Re: Certification Submittal for a Permanent Building Certificate of Occupancy (C.O.)
for **Lomas Car Wash**, [J-20 / D003]
9939 Lomas NE
Engineer's Stamp Dated 03/02/11

Re: Lomas Car Wash, Grading and Drainage Plan
Engineer's Stamp date 03-06-2010 (J20/D003)

**RE: Grading and Drainage Plan
Lomas Car wash, J20/D003**

**Re: Lomas Car Wash, 9935 Lomas Blvd NE, Traffic Circulation Layout
Engineer's Stamp dated 05-05-10 (J10-D003)**

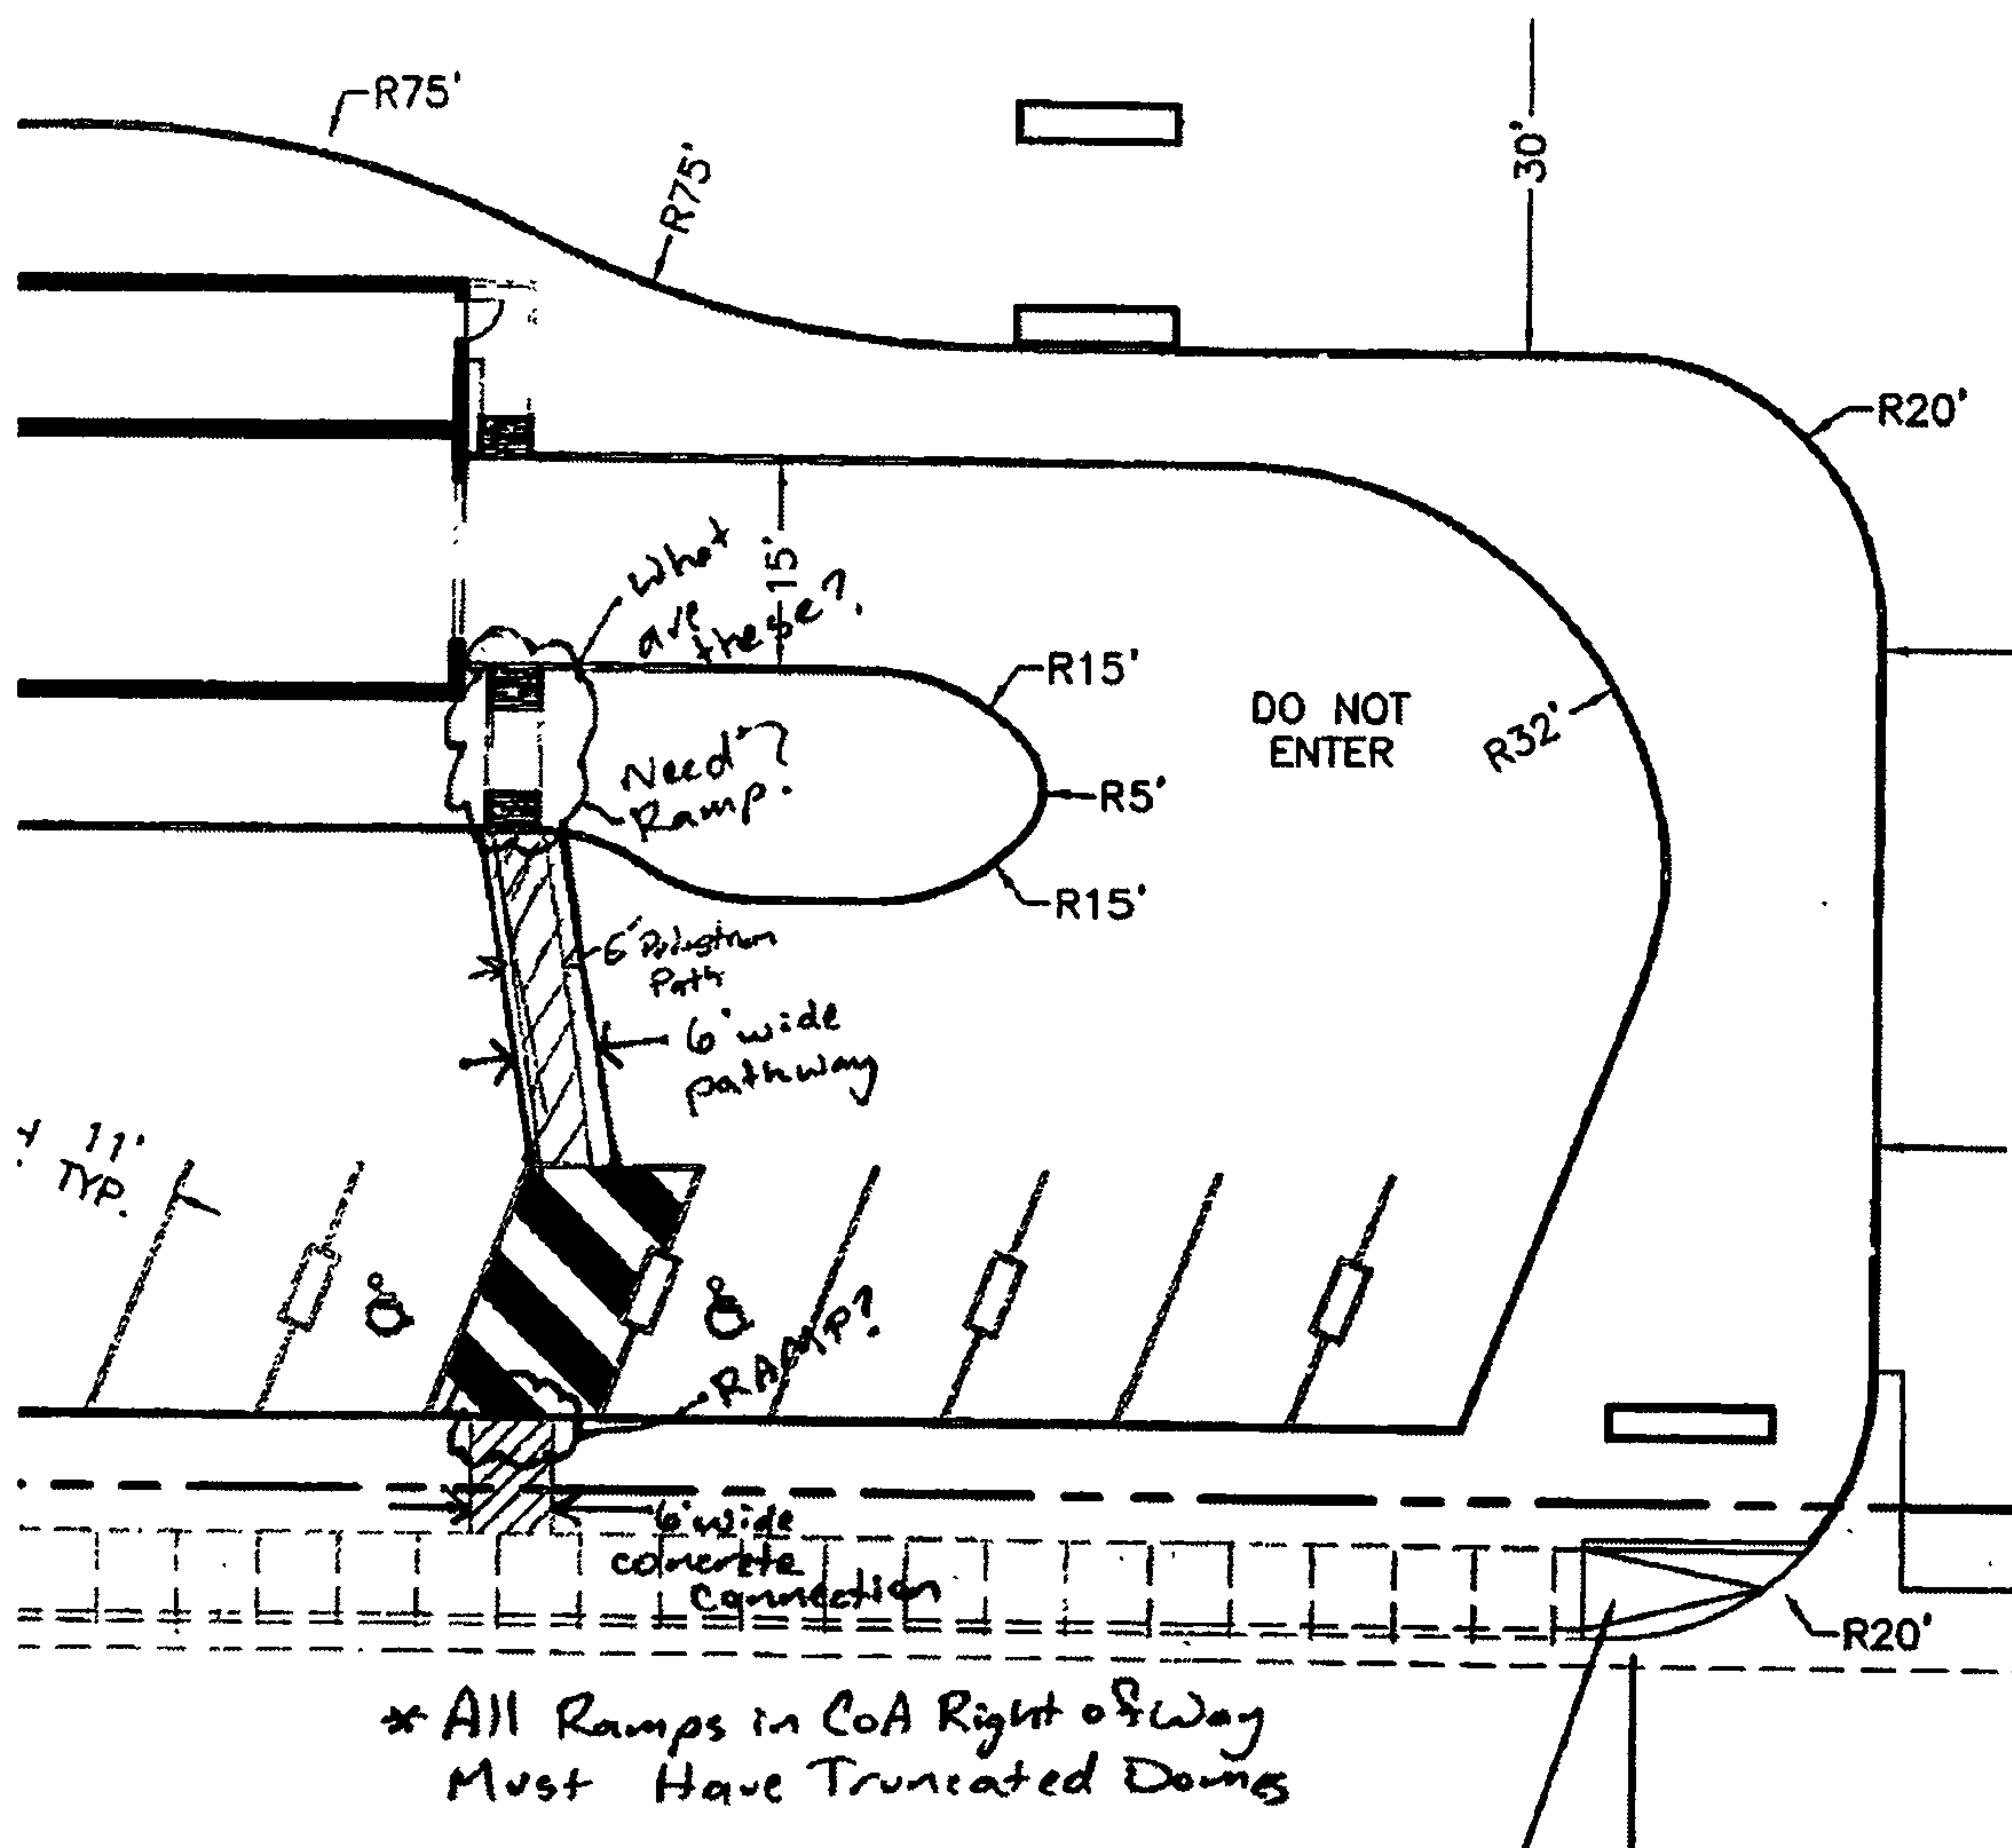
1. All ramps located in City of Albuquerque right of way must have truncated domes. Please add truncated domes to the detail titled "Uni-Directional Wheelchair Ramp w/ Ex. Pole Detail" or add a general note.
2. Clearly show the 6 foot wide, ADA accessible, pedestrian connection from Lomas Blvd. to the building. Show all ramps, if needed, and provide details. Please note that the connection is concrete from Lomas to the handicapped access aisle.
3. The pedestrian pathway from the handicapped access aisle to the building must be to scale. Please clarify if a ramp is required, as well as defining what is located both east and west of the proposed carwash. Are these stairs?
